## Draft Interim Review of PRM-50-93/95 Issues Related to the CORA Tests

Figure 1. Distribution of maximum heatup rates for CORA Tests when thermocouple temperatures are  $T < 1200$  C.

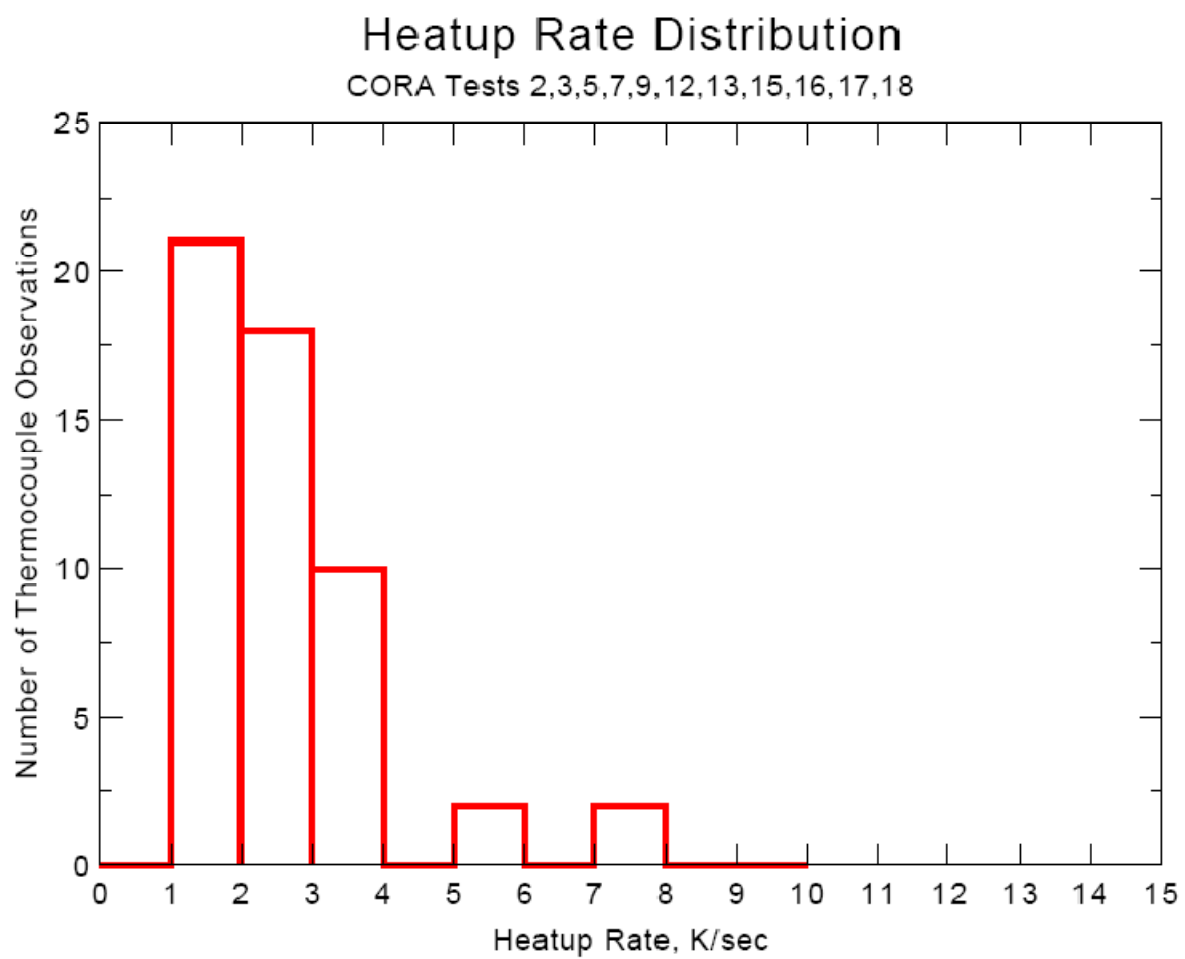
The petition is inaccurate in its characterization of the CORA tests. These tests were severe fuel damage tests, and conditions were designed to produce temperatures exceeding 2200 °F and relocation of parts of the fuel bundle. The data does show temperatures that increase at nearly 15 K/sec, however this rate of increase did not occur while temperatures were less than 2200 °F. As intended in the CORA tests, the heatup rate was initially about 1 K/sec. The rate of temperature increase did escalate as temperatures exceeded 1100 degrees Celsius (°C) (2012 °F). As temperatures approached 2200 °F, the rate of increase was generally 3 to 4 K/sec and only a few thermocouples had a more rapid heatup. Figure 1 shows a histogram of the thermocouple heatup rate distribution obtained by an evaluation of results from CORA Tests 2, 3, 5, 7, 9, 12, 13, 15, 16, 17, and 18. This includes all of the tests specifically mentioned in the

petition and related public comments. The median heatup rate of these thermocouples was approximately 2.25 K/sec, well below the 15 K/sec rate that is suggested as evidence of an autocatalytic reaction.

The distribution in Figure 1 identified only four locations in which the heatup rate exceeded 4 K/sec. While each of these locations had heatup rates well below that which might be considered autocatalytic, these apparent outliers received additional consideration. Each outlier was found to be located in the bottom half of the rod bundle. Figure 2 shows the heatup rate as a function of elevation in the bundle. The elevations of these outliers were 350 mm or less from the bottom. Two of these outliers occurred in Test 12 at 350 mm (7.5 K/sec) and at 250 mm (5.7 K/sec). However, when the heatup rates at these locations achieved their maximum (while the temperature was below 1200 °C), the upper part of the bundle had already started to melt and relocate. Figures 27 and 34 from the data report (Sepold et al., 2009a) show photographs from post-test examination of the bundle. Relocated material is clearly evident at the 350 mm and 250 mm elevations. While not specifically discussed in the data report (Sepold et al., 2009), these heatup rates occurred roughly 300 seconds later than when the absorber rods relocated. Thus, relocation of molten material and “candling” are likely causes of these isolated heatup rates. The measured hydrogen production rate in Test 12 during this period is also notable. At approximately 4300 seconds when elevations 350 and 250 mm achieved their maximum heatup rates while below 1200 °C, the hydrogen generation rate was increasing but leveled off by 4500 seconds. If an “autocatalytic” had actually occurred, then the hydrogen generation rate would have continued to increase.

The staff concludes that the behavior of temperatures in the CORA experiments is consistent with prior understanding and expectations on oxidation rate at temperatures below 2200 °F. No locations with temperatures less than 2200 °F with heatup rates greater than 10 K/sec were identified. The heatup rates below 2200 °F do not indicate a presence of an exothermic "autocatalytic" reaction. The results of CORA do not suggest that the Cathcart-Pawel or Baker-Just correlations are non-conservative. The assertions made by the petition with regards to Cathcart-Pawel and Baker-Just are not substantiated by the CORA data.

Figure 2. Maximum heatup rate in CORA tests with elevation.

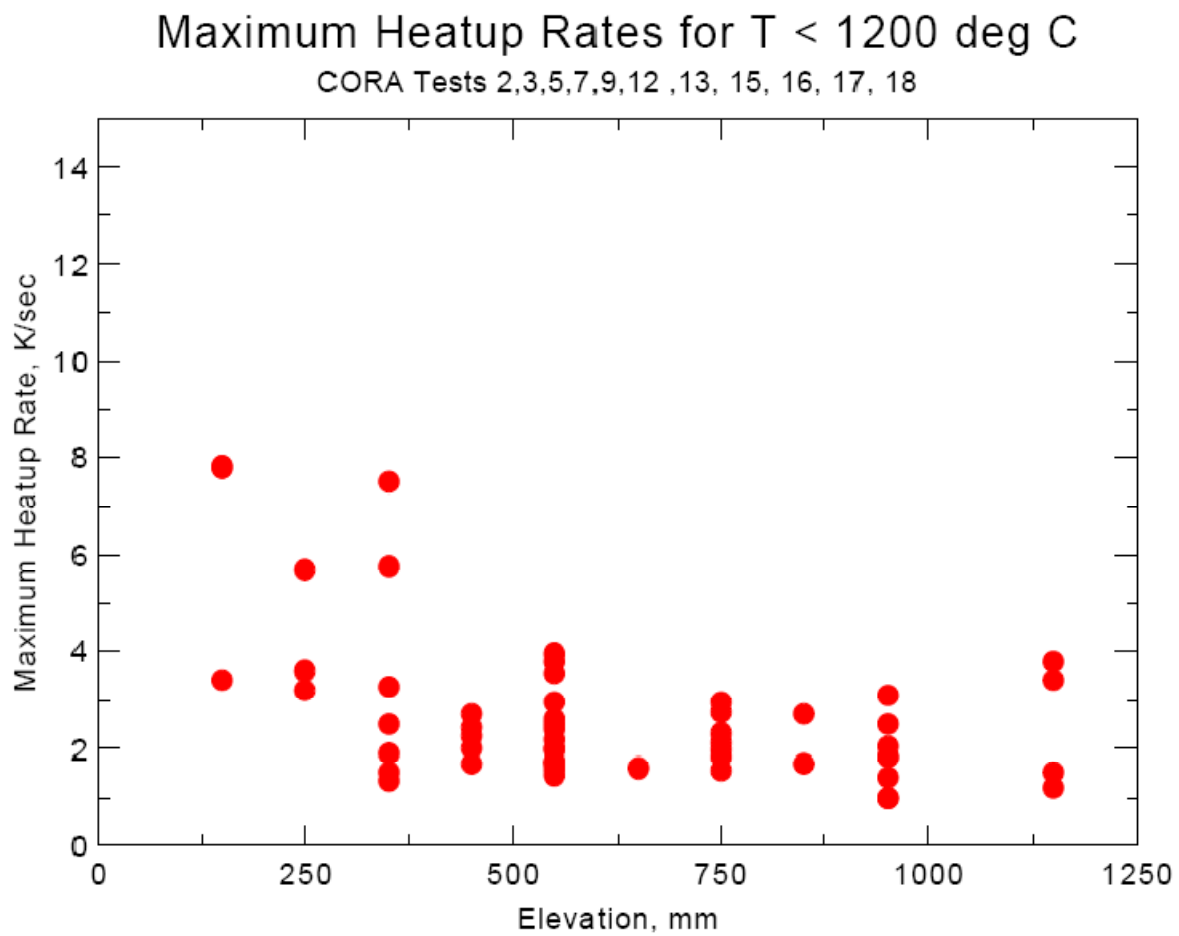
The other heatup rates that appeared to be outliers occurred in Test 16 (7.8 K/sec) at 150 mm and in Test 13 (5.8 K/sec) at 350 mm. The results from Test 16 are described by Sepold et al., 2009b and Test 13 by Firnhaber et al., 1993. As with Test 12, the maximum heatup rates at these elevations occurred several hundred seconds following the time at which melt and relocation was initiated in the upper part of the bundle. Post-test examinations confirmed the relocation of material to the lower parts of the bundle. The increased heatup rates are likely due to the relocation of molten material at these elevations. Again, as in Test 12, the hydrogen generation rates showed no signs of an autocatalytic reaction when the maximum heatup rates were observed. The hydrogen generation rates in Test 16 and 13 did not show evidence of an autocatalytic reaction at these times.
